**TOWN OF MOUNTAIN VILLAGE
REGULAR DESIGN REVIEW BOARD MEETING
THURSDAY OCTOBER 3, 2019 10:00 AM
2nd FLOOR CONFERENCE ROOM, MOUNTAIN VILLAGE TOWN HALL
455 MOUNTAIN VILLAGE BLVD, MOUNTAIN VILLAGE, COLORADO
REVISED AGENDA**

TO: Design Review Board
FROM: Sam Starr, Planner
FOR: Meeting of October 3rd, 2019
DATE: September 26, 2019
RE: Design Review: Final Review for a new single-family home on Lot BC105,114 Lawson Overlook

TO: Design Review Board
FROM: Sam Starr, Planner
FOR: Meeting of September 5, 2019
DATE: September 26, 2019
RE: Initial Architectural and Site Review for a new single-family home on Lot AR-53R2, 125 Adams Way

2 DETAIL- RAILING @ NORTH DECK
3" = 1'-0"

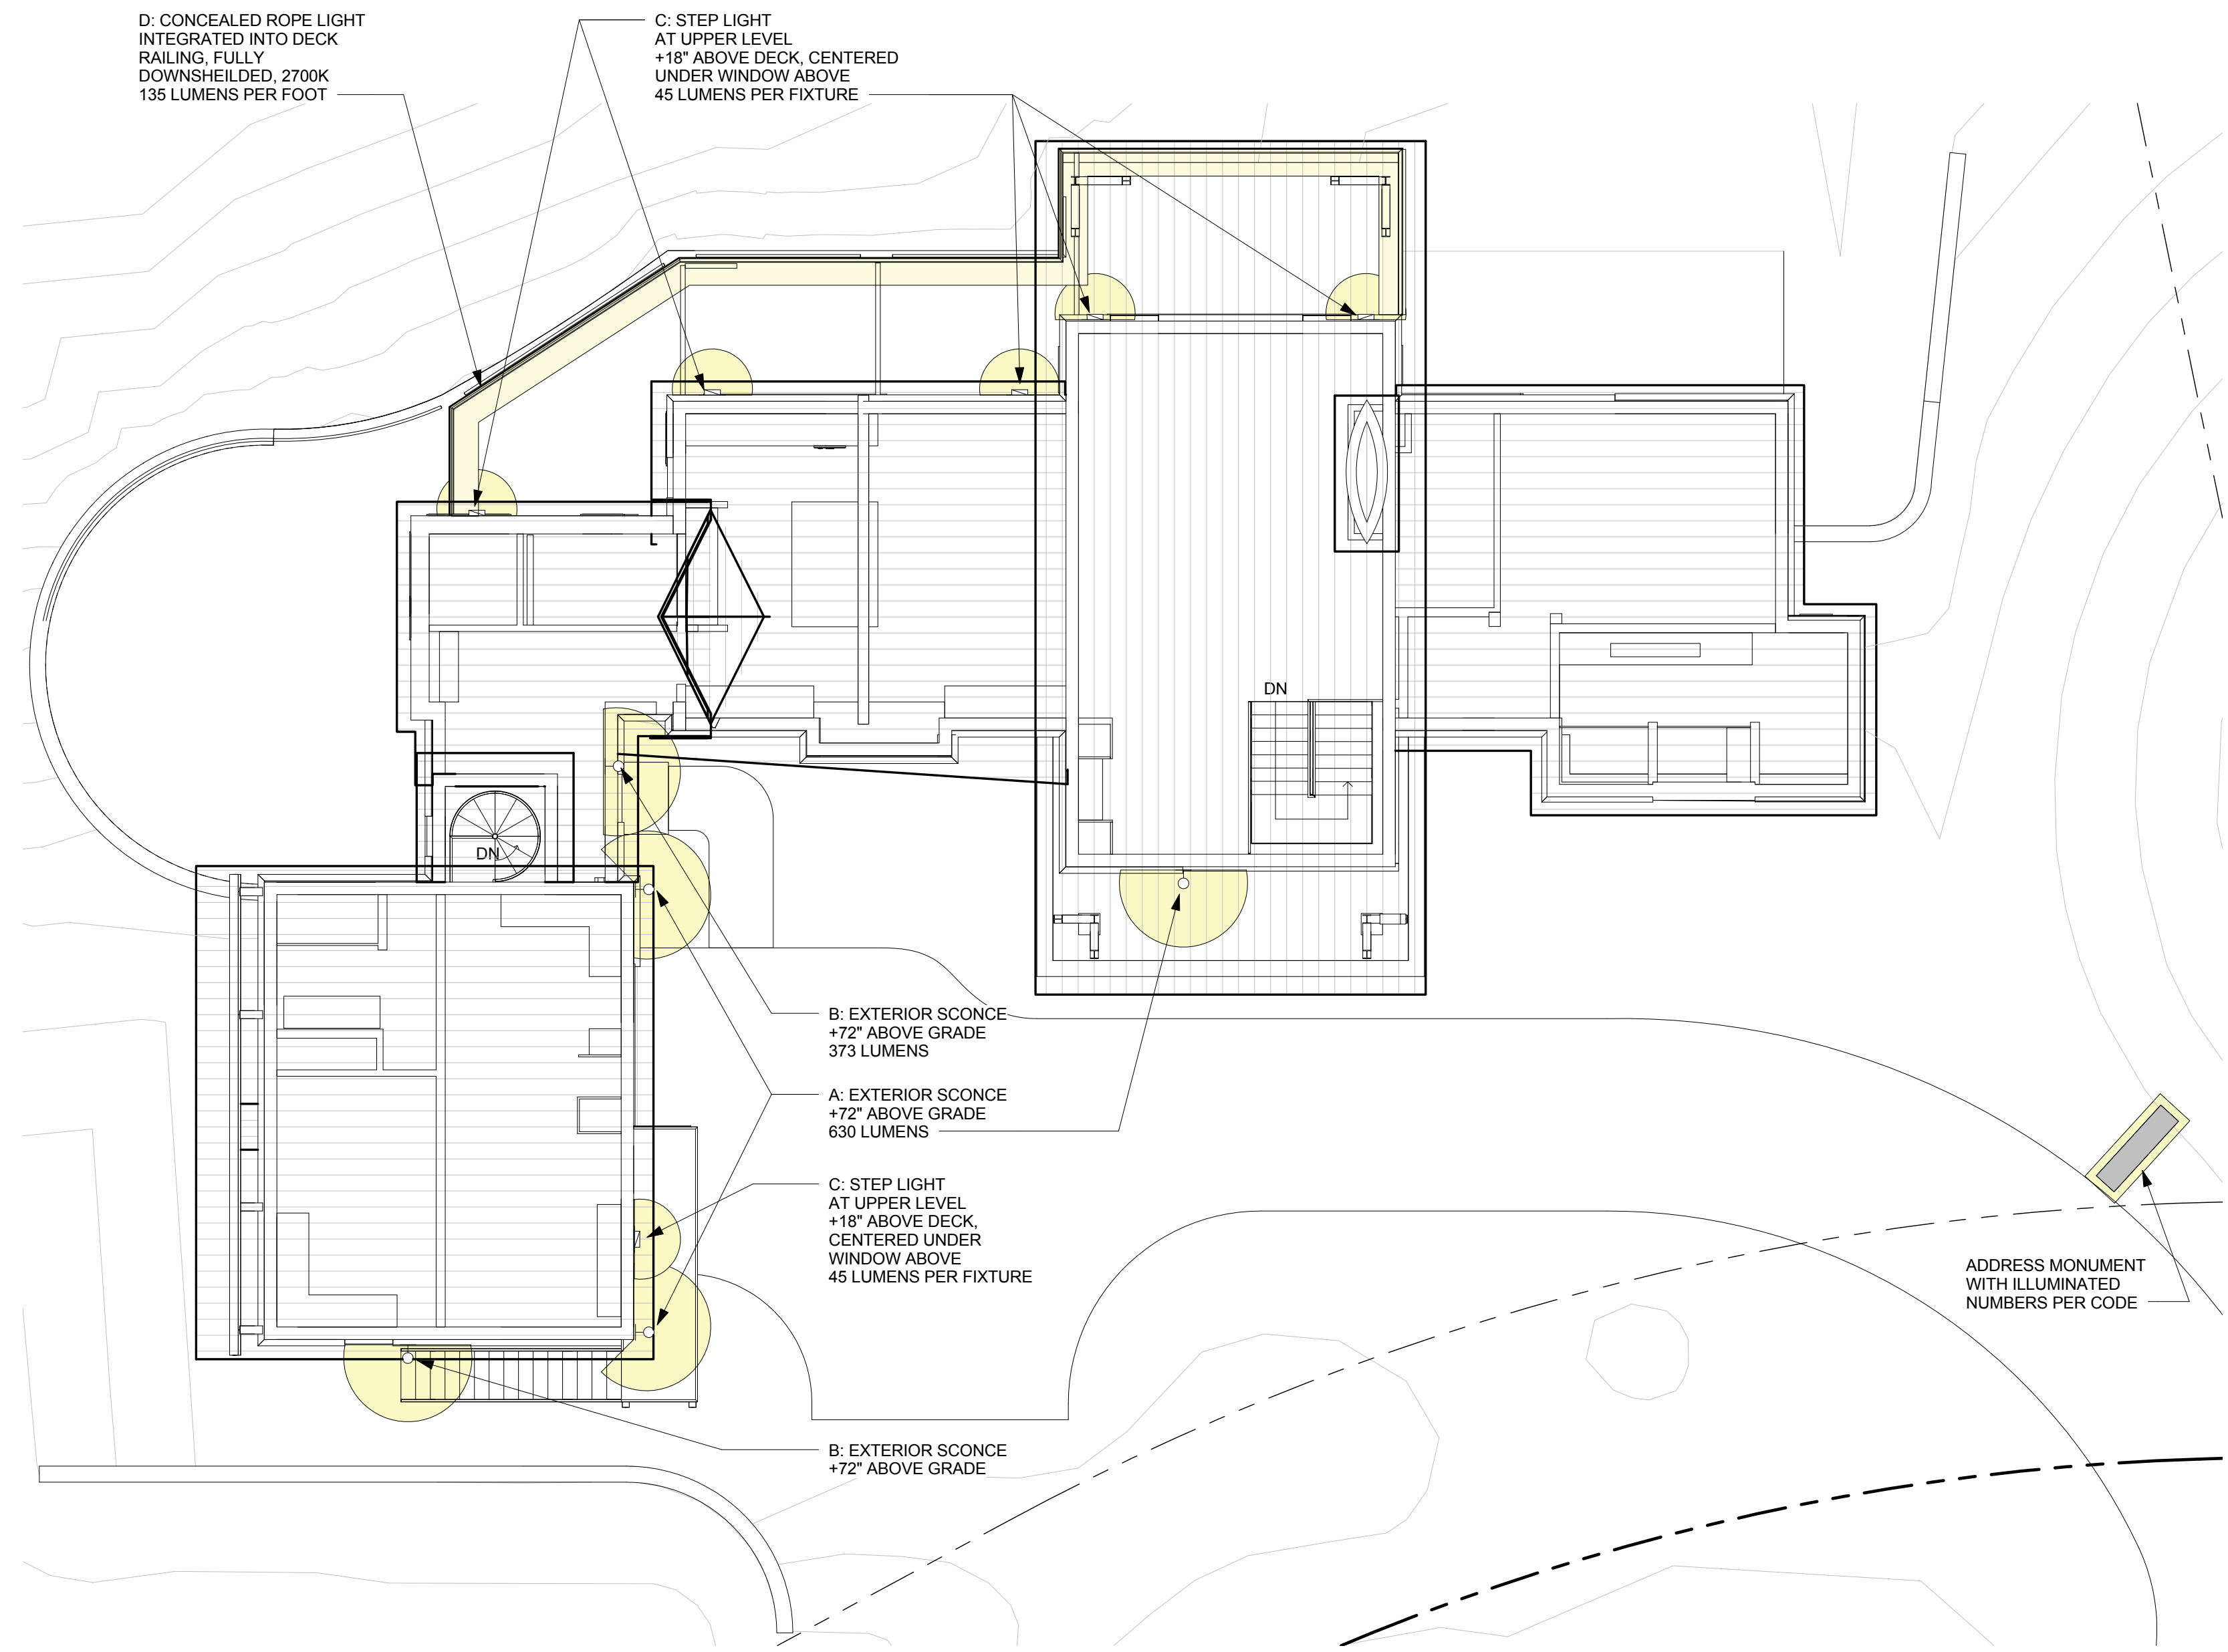
The revised lighting regulations include fewer lights, and the placement of lighting is code compliant. Proposed lighting locations include: decks, exterior egress areas, and the entryway. All fixtures meet the updated lumens and maximum temperature thresholds, and do not exceed the maximum allowed 84” in height. Staff recommends that an isometric foot candle study is prepared prior to issuance of a building permit to ensure that light spill does not occur on this site.

- 4. Applicant shall submit an exterior lighting plan prepared by a licensed professional that includes an isometric foot-candle diagram, and dimmer/lighting management system information to be reviewed by staff and DRB Chairperson or DRB Chairperson designate.*

5 ADDRESS MONUMENT PLAN DETAIL
SCALE: 3/4" = 1'-0"

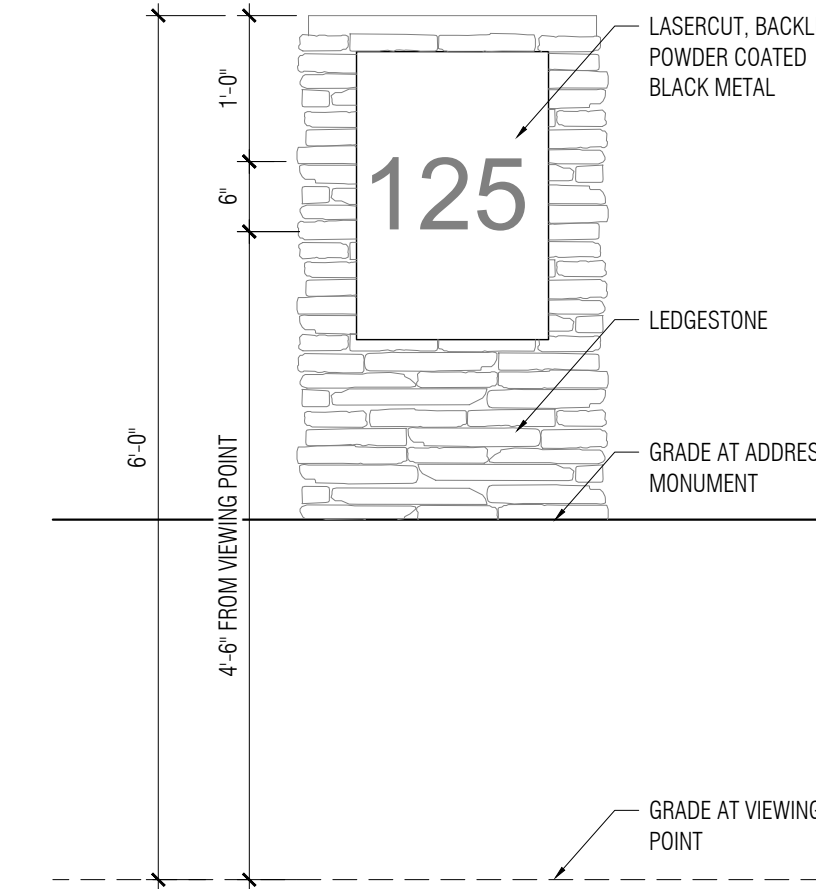
5. *Prior to Final Review, Applicant shall provide a revised address identification sign schematic that contains downlighting and numbers coated in a reflective paint.*
